CITY OF CAMBRIDGE
BUILDING DIVISION

THESE PLANS have been examined for compliance
with the Ontario Building Code Requirements. A
Building Permit is in Order to issue subject to any
changes noted under the condition that the building will
be constructed in accordance with the code

BASEMENT PLAN EL-1
BARLASSINA CONSTRUCTION
CITY OF CAMBRIDGE

MODEL:
GARDEN 2
SCALE:
3/16"=1'-0"
PROJ. No.
21-35
DWG. No.
1

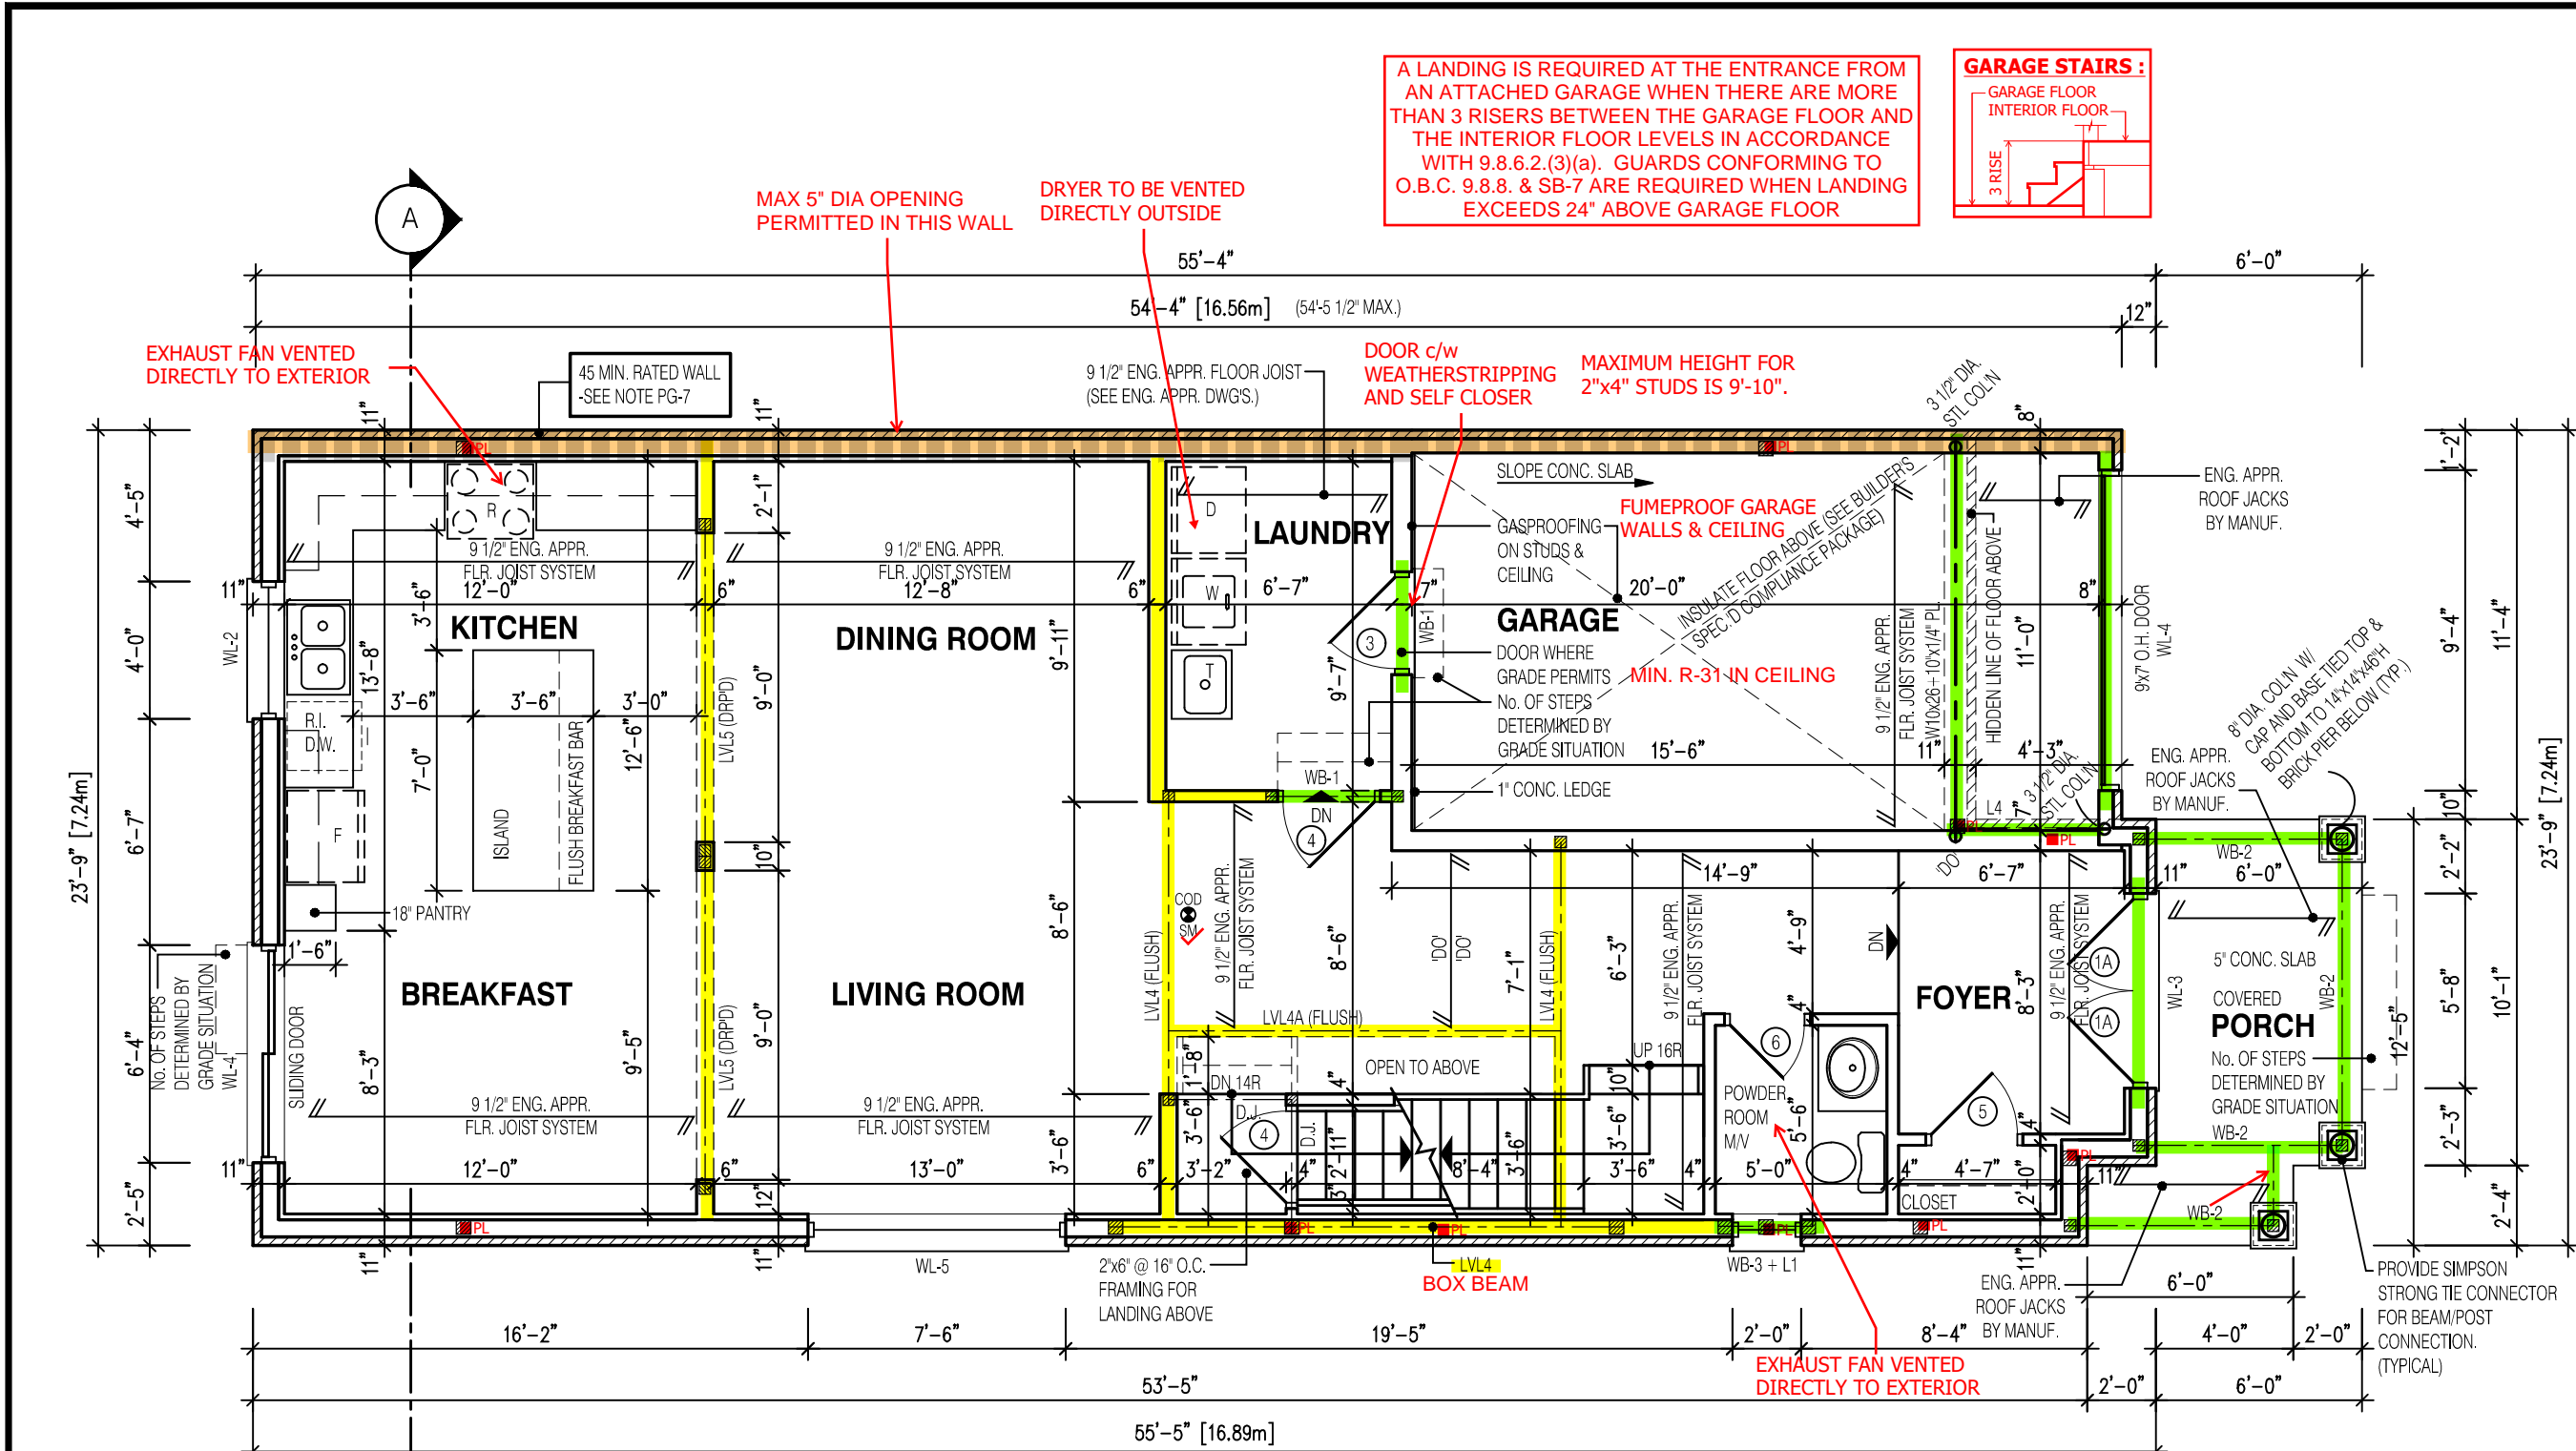
P.ENG SOILS REPORT IS REQ'D TO
CONFIRM BEARING CAPACITY OF
SOILS. SEE FIELD INSPECTOR

REINFORCING REQUIRED IN FOUNDATION
WALL OR PORCH SLAB SHALL BE
REVIEWED PRIOR TO POURING CONCRETE
(see inspector)

3 1/2"x 3 1/2"x 1/4" STEEL BRICK ANGLE
TYPICAL UP TO MAX. 8'-1" SPAN
VERIFY WATER METER AND DWHR
UNIT LOCATION WITH INSPECTOR

WATER METER TO BE INSTALLED WITHIN 2m
(6'-6") FROM THE POINT THE WATER SERVICE
PIPE MEETS THE BUILDING LINE

FIRST FLOOR PLAN EL-1

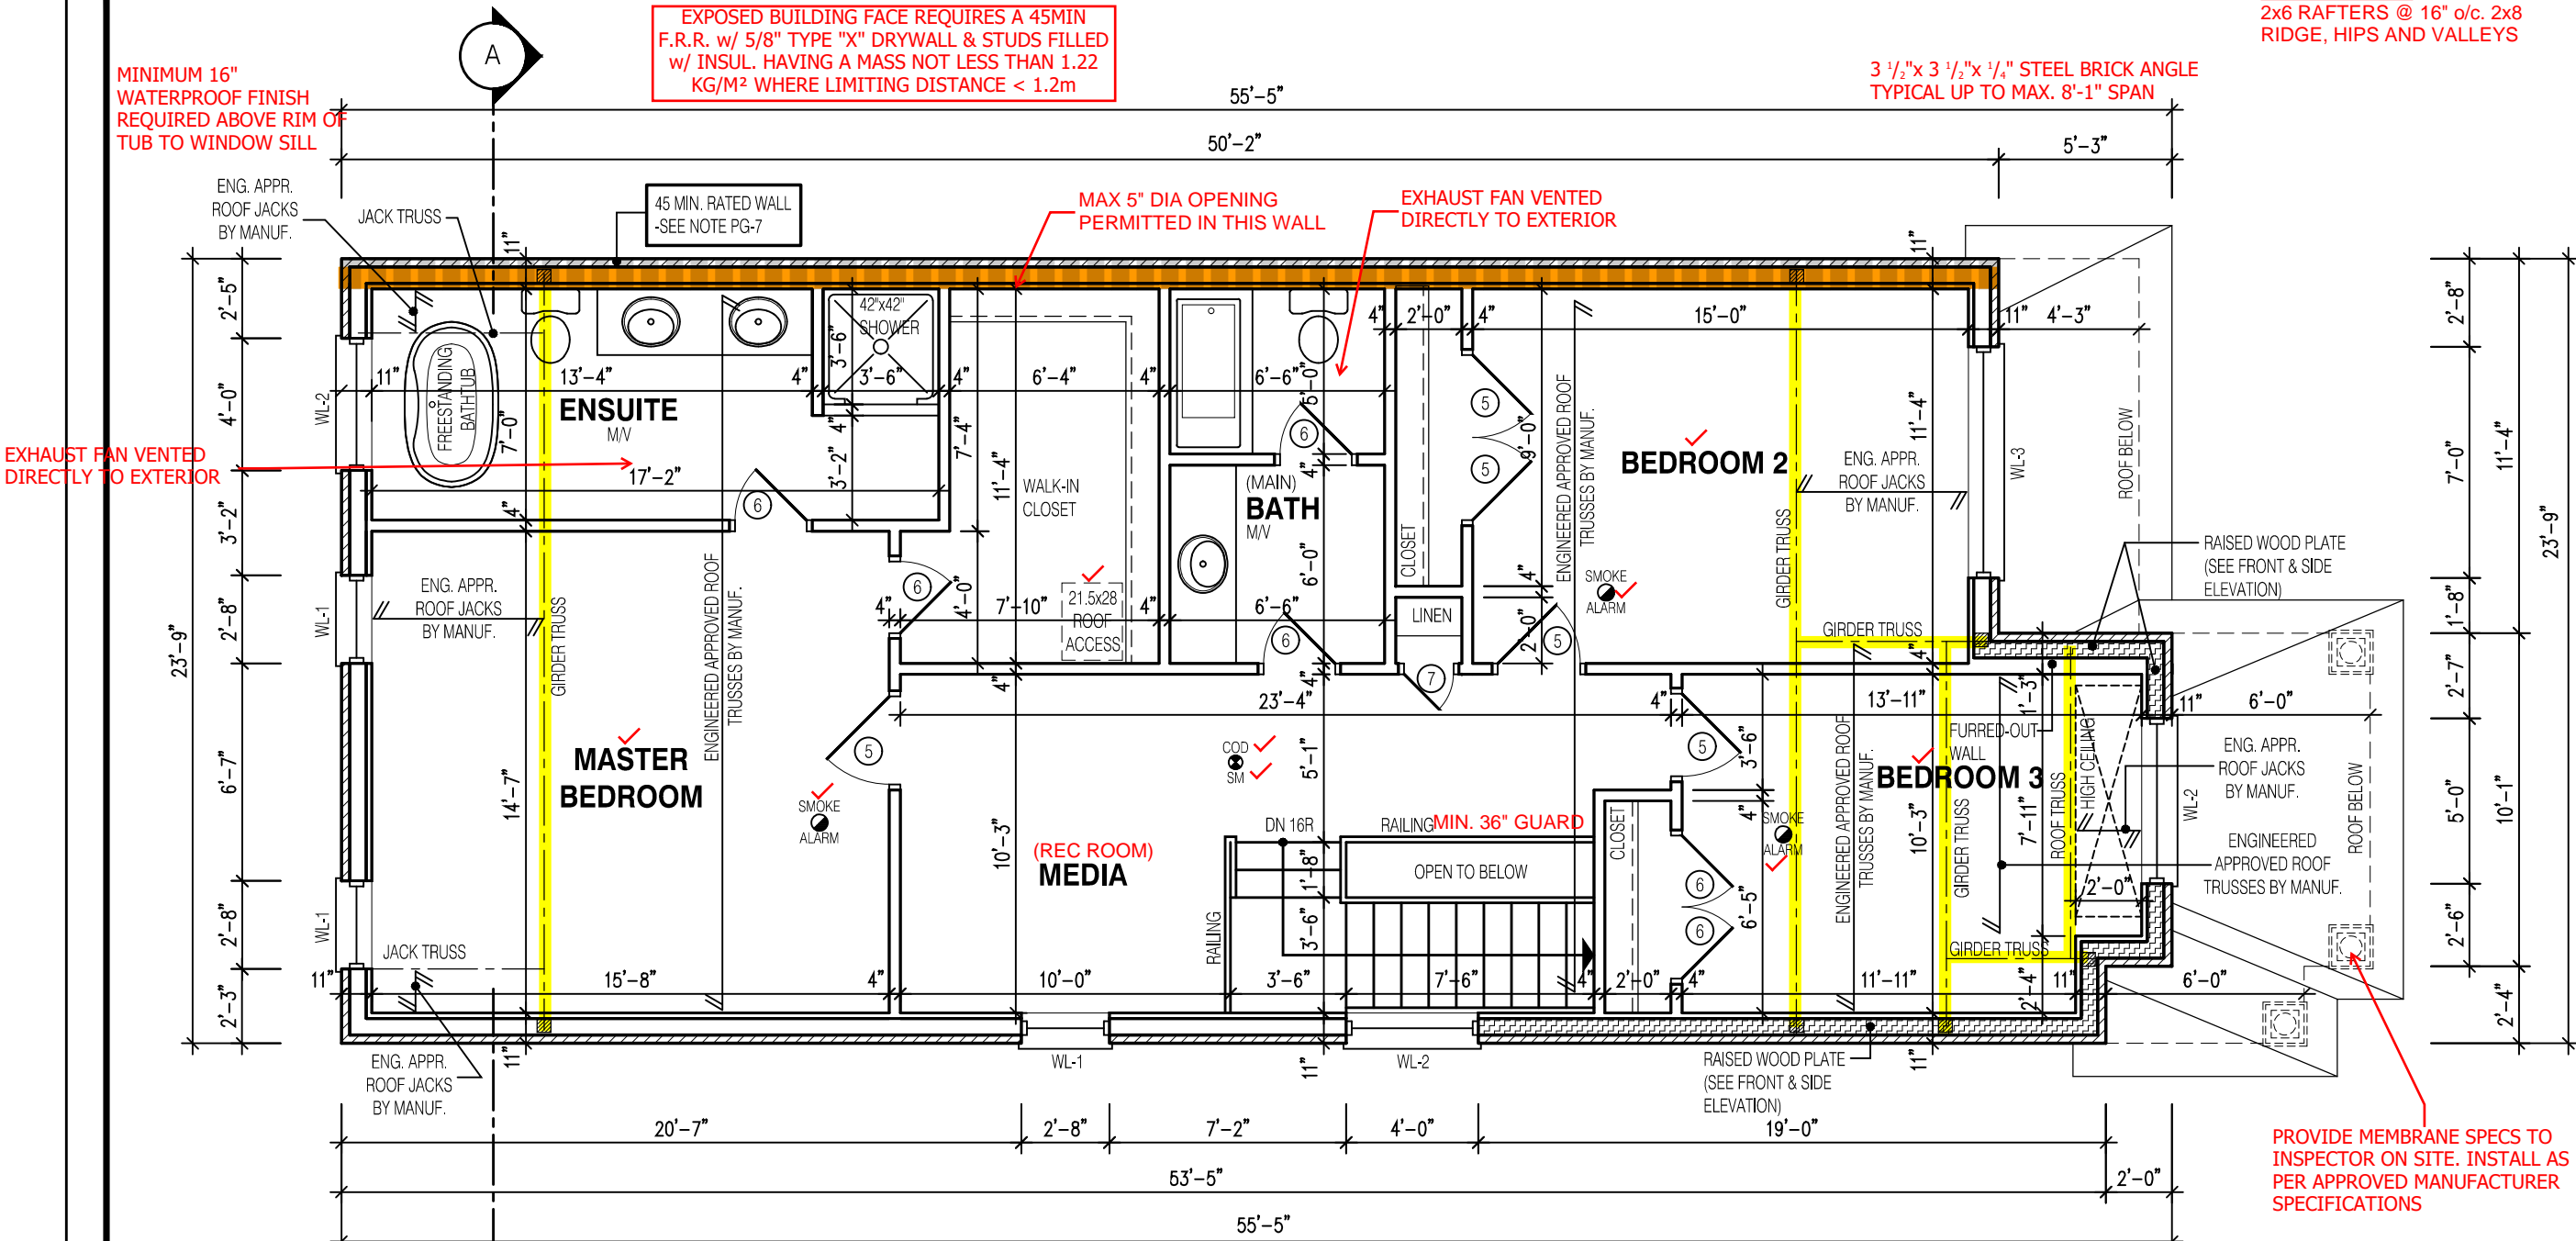
***TRACE ALL POINT LOADS THROUGH FLOOR SYSTEM TO SOLID BEARING BELOW**

PROVIDE MEMBRANE SPECS TO INSPECTOR ON SITE. INSTALL AS PER APPROVED MANUFACTURER SPECIFICATIONS

PART. DECK PLAN- EL-1
BARLASSINA CONSTRUCTION
CITY OF CAMBRIDGE

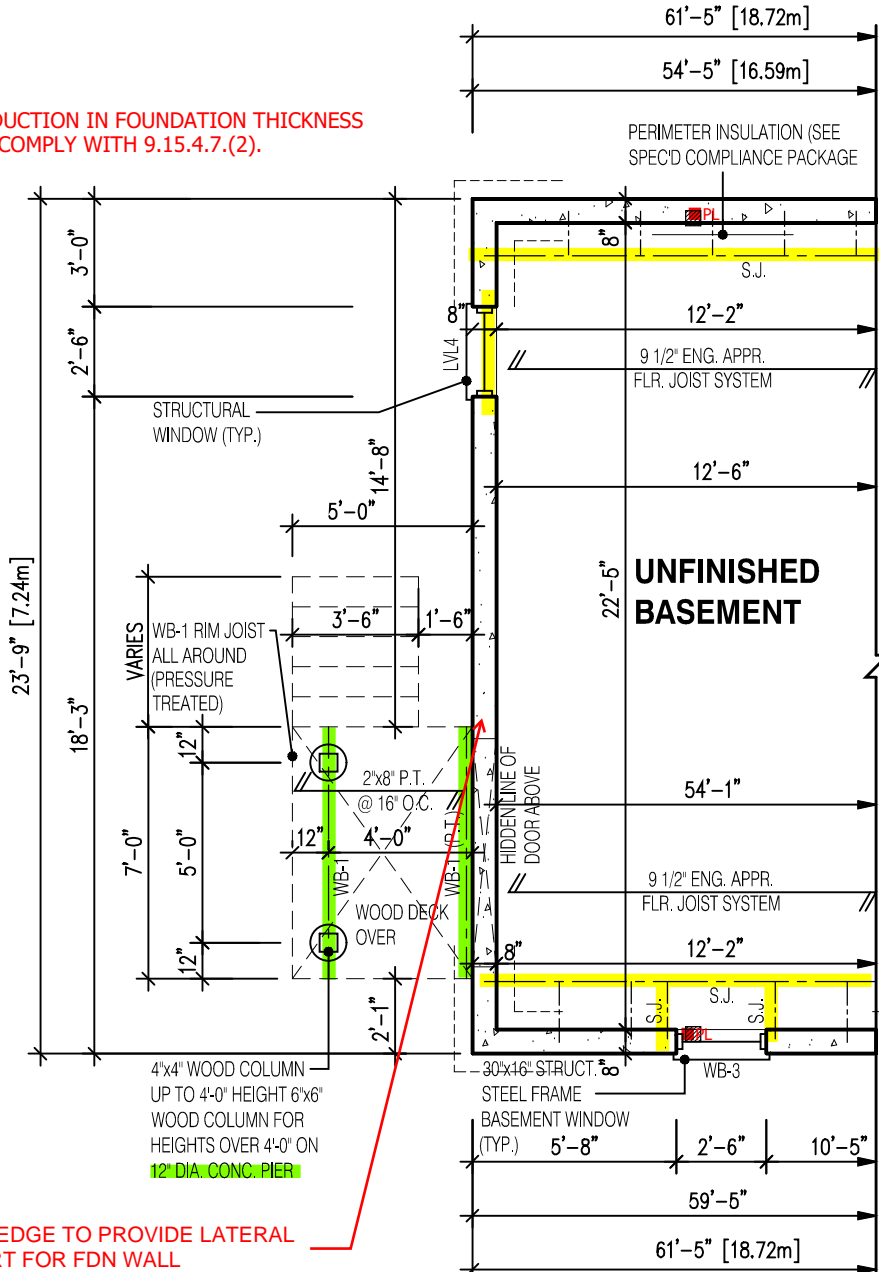
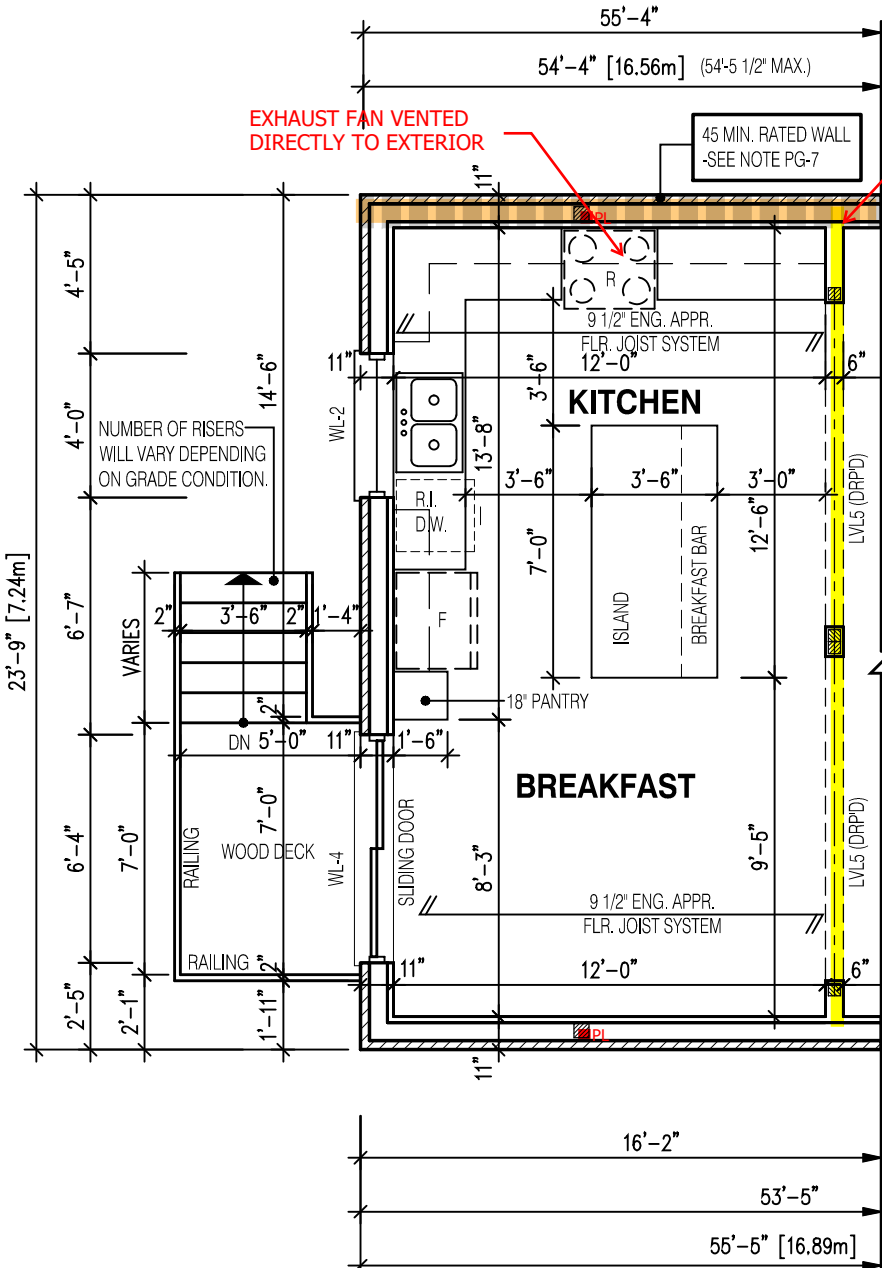
ALL GUARDS TO COMPLY WITH SB-7 OR P.ENG DESIGN. GUARDS TO BE MIN. 36" HIGH (900mm). WHERE DECK WALKING SURFACE TO FIN. GRADE EXCEEDS 5'-11" (1.8m), GUARD HEIGHT TO BE 42" HIGH (1.2m)

ENSURE P.ENG STAMPED RAILING DOCUMENTATION AND ATTACHMENT DETAILS ARE AVAILABLE FOR REVIEW BY THE INSPECTOR
